Form 3160-5
(June 2019)UNITED STATES
DEPARTMENT OF THE INTERIOR
BUREAU OF LAND MANAGEMENTFORM APPROVED
OMB No. 1004-0137
Expires: October 31, 2021**SUNDRY NOTICES AND REPORTS ON WELLS**
Do not use this form for proposals to drill or to re-enter an abandoned well. Use Form 3160-3 (APD) for such proposals.

8. Well Name and No. BANJO 5 FED COM/767H

Banjo 5 Fed Com 518H (FKA 767H) API #: 30-015-48291

EOG respectfully requests an amendment to our approved APD for this well to reflect the following changes:

WELL LOCATION AND ACREAGE DEDICATION PLAT

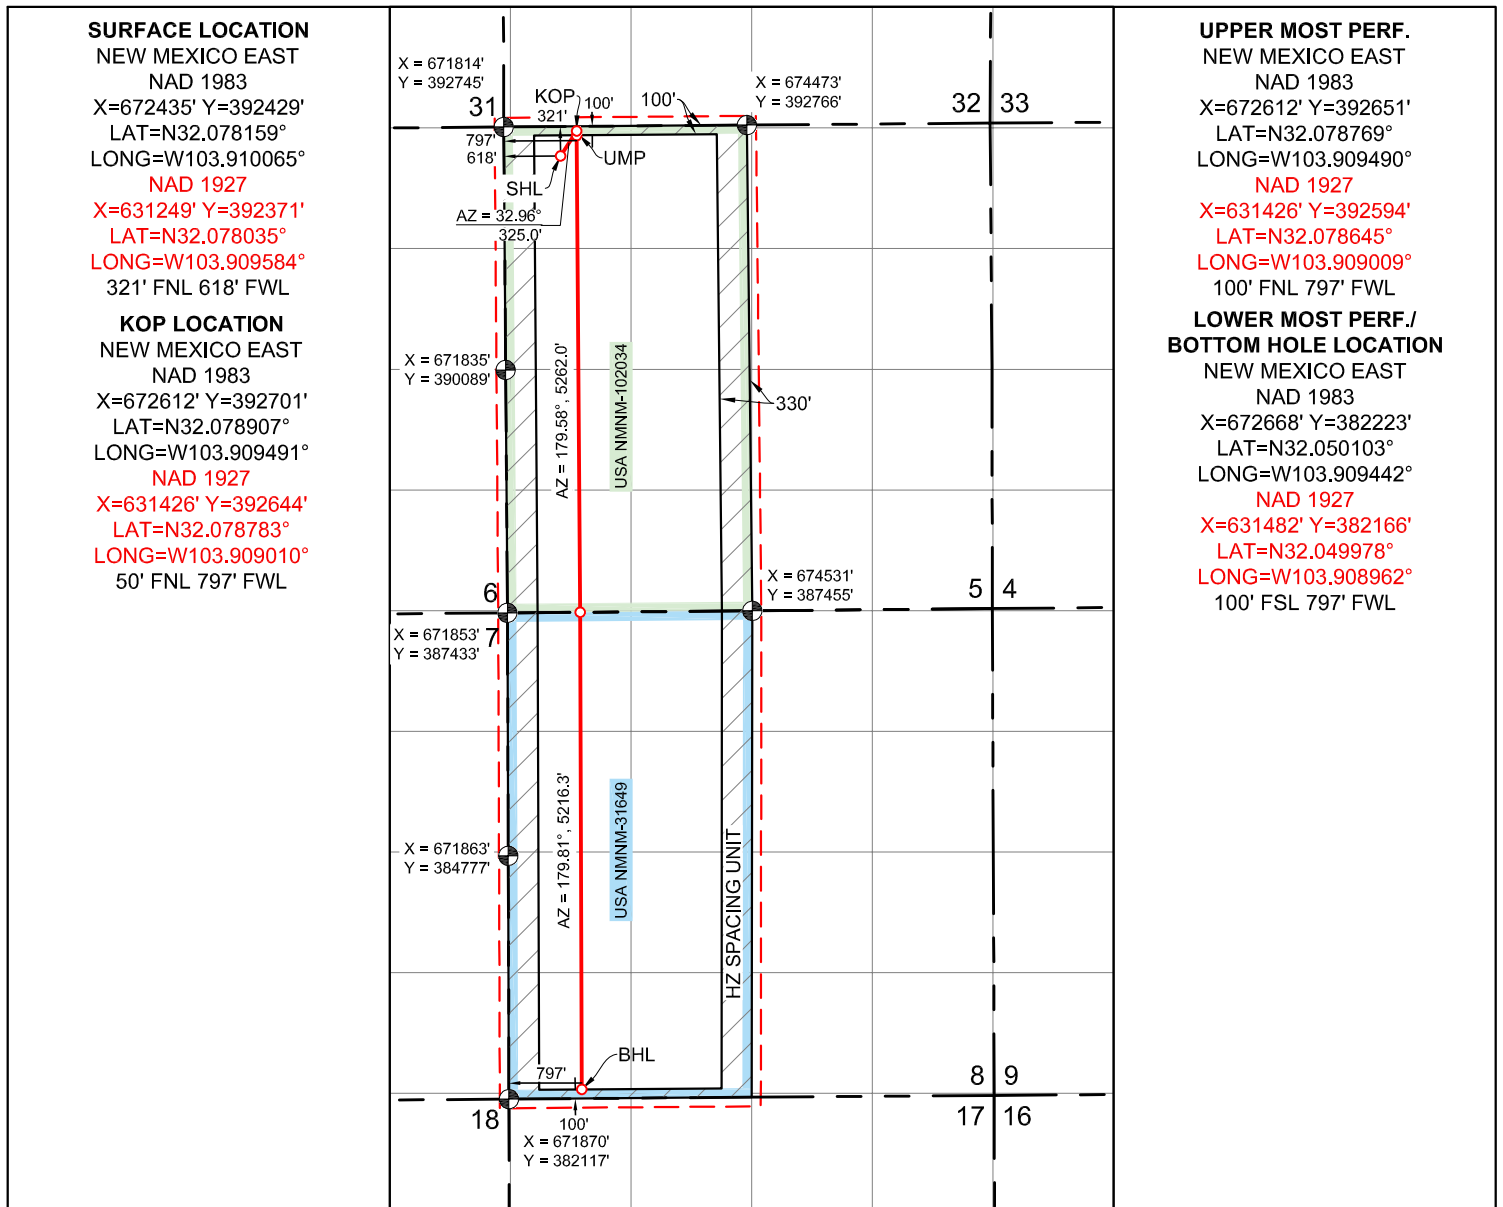
Change BHL from T-26-S, R-30-E, Sec 8, 230' FSL, 660' FWL, Eddy Co., NM, to T-26-S, R-30-E, Sec 8, 100' FSL, 797' FWL, Eddy Co., N.M.

Update the Pool as reflected in the C-102.

UL or lot no.	Section	Township	Range	Lot Idn	Feet from the	North/South line	Feet from the	East/West line	County
M	8	26 S	30 E		100	SOUTH	797	WEST	EDDY

Revised Wellbore A:

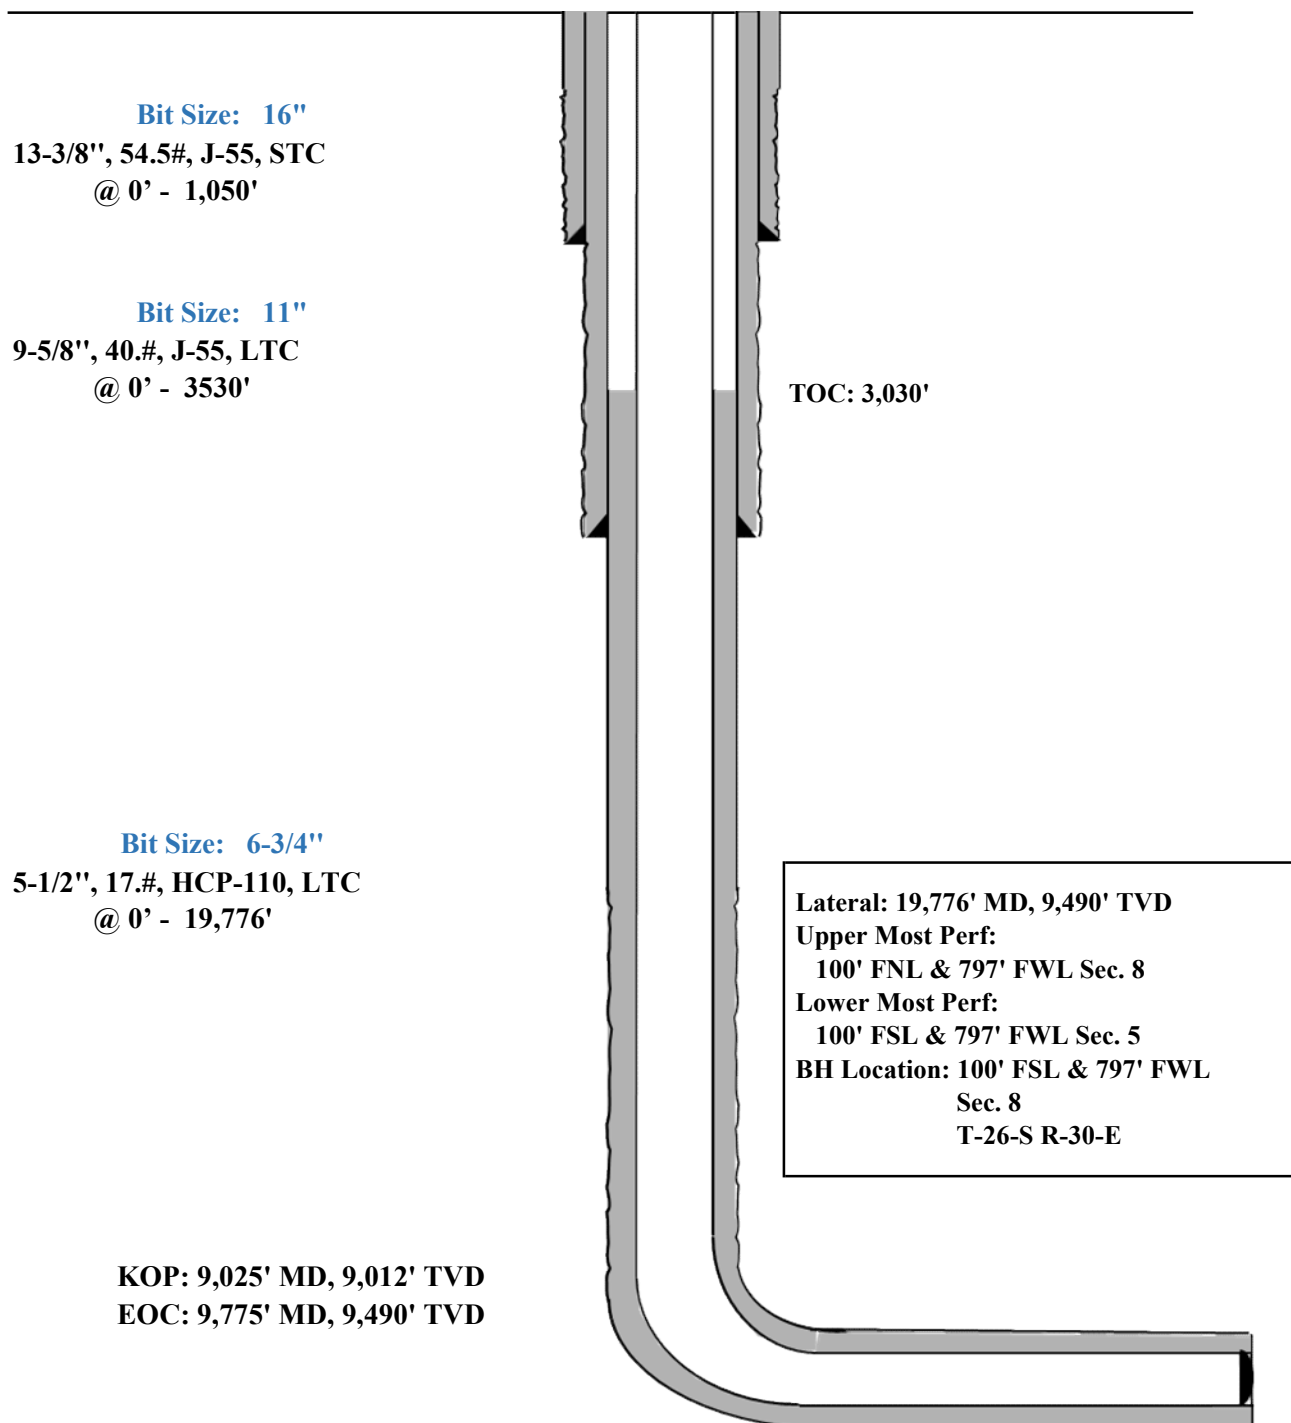
Update casing and cement program to current design.

Casing Program A:

Hole Size	Interval MD		Interval TVD		Csg OD	Weight	Grade	Conn
	From (ft)	To (ft)	From (ft)	To (ft)				
16"	0	1,050	0	1,050	13-3/8"	54.5#	J-55	STC
11"	0	3,543	0	3,530	9-5/8"	40#	J-55	LTC
6-3/4"	0	19,776	0	9,490	5-1/2"	17#	HCP-110	LTC

Design A

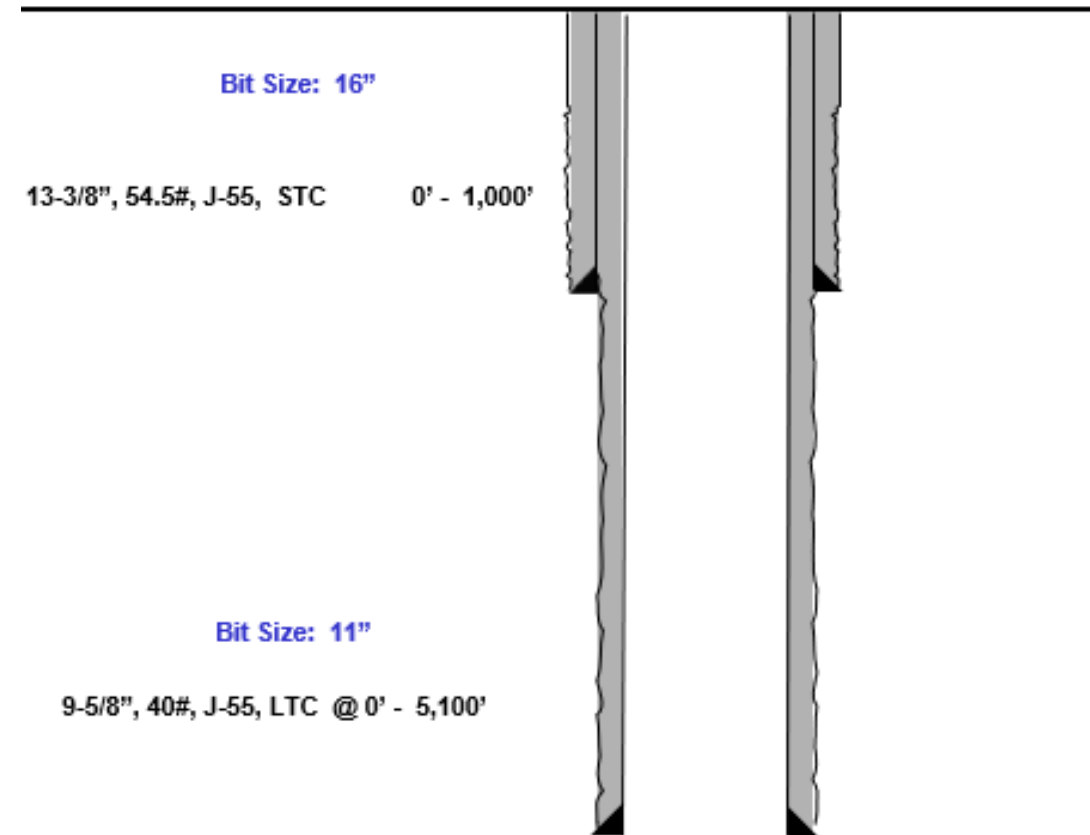
EOG request permission to allow deviation from the 0.422" annulus clearance requirement for the intermediate (salt) section from Onshore Order #2 under the following conditions:

Proposed 11" Hole with 9.625" 40# J55/HCK55 LTC Casing

- 11" Bit + 0.52" Average hole enlargement = 11.52" Hole Size
 - 0.9475" Clearance to casing OD

$$= \frac{11.52 - 9.625}{2}$$
 - 0.4475" Clearance to coupling OD

$$= \frac{11.52 - 10.625}{2}$$
- Previous Shoe – 13.375" 54.5# J55 STC
 - 0.995" Clearance to coupling OD (~1,200' overlap)

$$= \frac{12.615 - 10.625}{2}$$
